FAQ Number 13-0002 FAQ Revision 0n1

FAQ Title Modeling of Main Control Room Abandonment on Loss of Habitability

Plant: Various Date: 16~~3~~ AugustJuly 2013

To clarify the expectation for modeling of control room abandonment for fire scenarios in the main control room (MCR) that lead to a loss of habitability.

Figure 1 - Flow Chart for Abandonment Due to Loss of Habitability (LOH)

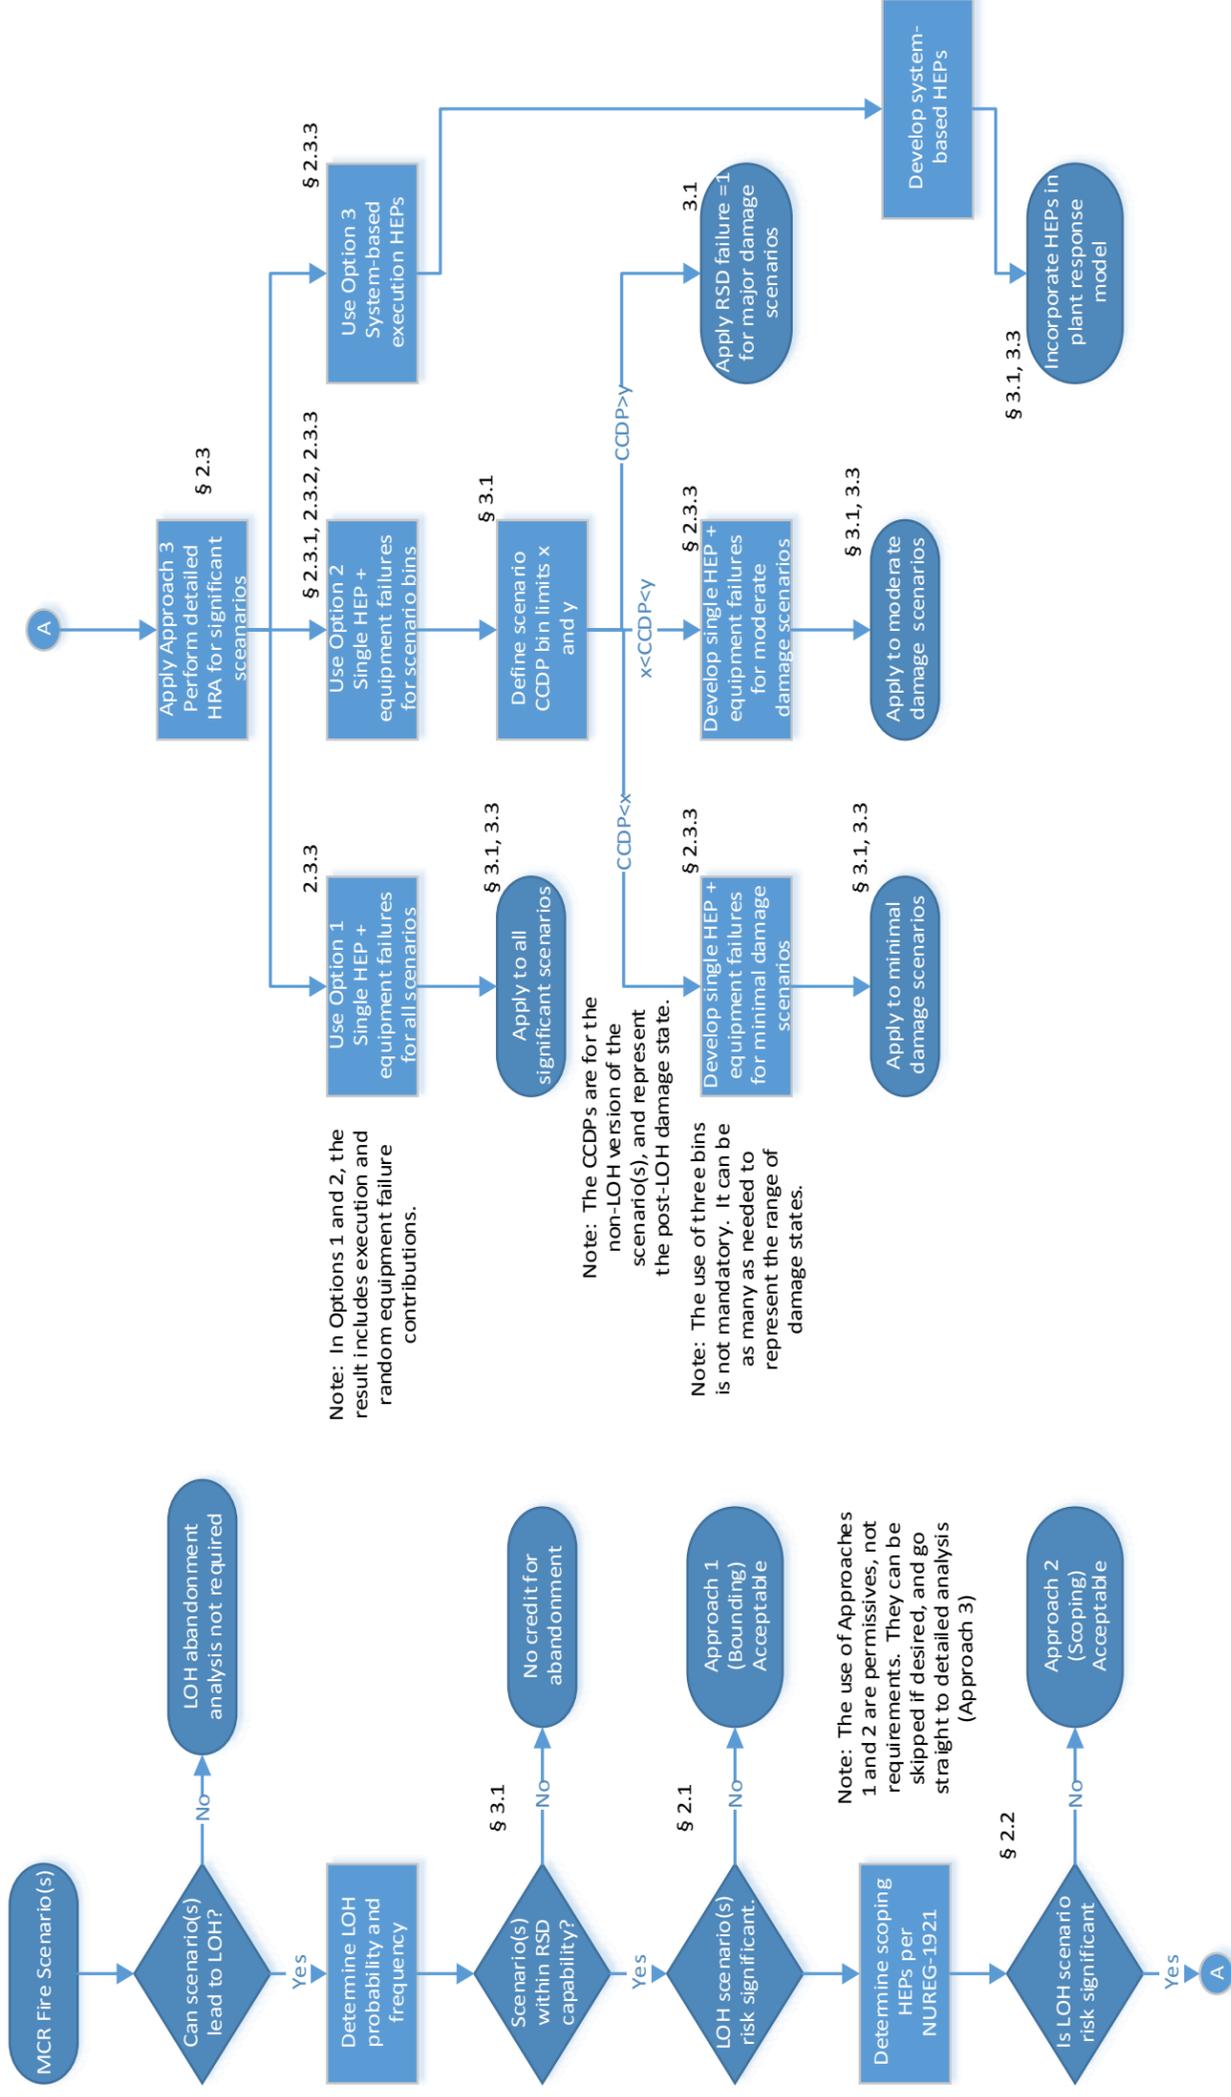
Comment [O9]: We need to have discussion regarding the figure. It's not clear first of all, why a single HEP constitutes a detailed HRA analysis. We need to understand the rationale here. Secondly, the discussion under Option 2 of Approach 3 seems to be overblown. We do not understand the need for such a complex addition to the table.

Comment [O23]: Again, we're not sure of the how behind developing the single HFE. Need to understand as discussed earlier with regards to the figure. The PRA Standard says that detailed analysis needs to address the scenario specific aspects that influence operator actions.

Comment [J52]: The table seems like overkill. Isn't the point to map sequences on MCR abandonment, and to use the most restrictive scenario from the bin for quantification? What else is the table conveying.

Comment [p10]: Further clarification is added later in the text. Summary of rationale is in the comments added below.

Comment [p11]: Rationale for option 1. If we accept the concept that scenarios can be binned and an HEP based on the worst case in a bin, then this simply address the case where there is only one bin (all LOH scenarios) and the worst case is used for the HEP. It is detailed because it is based on a plant-specific modeling of the procedures and actions required for that scenario.

Comment [p12]: Rationale for option 2. This addresses the option for binning scenarios based on CCDP bins. This was an approach that was used for some plants and that NRC said was acceptable. Including it in the FAQ establishes it as acceptable and provides guidance for applying it acceptably.

Comment [p24]: Clarification has been added based on our prior discussions.

Comment [p53]: Again, this approach was used by some plants and was found agreeable by NRC. We would like to document that.
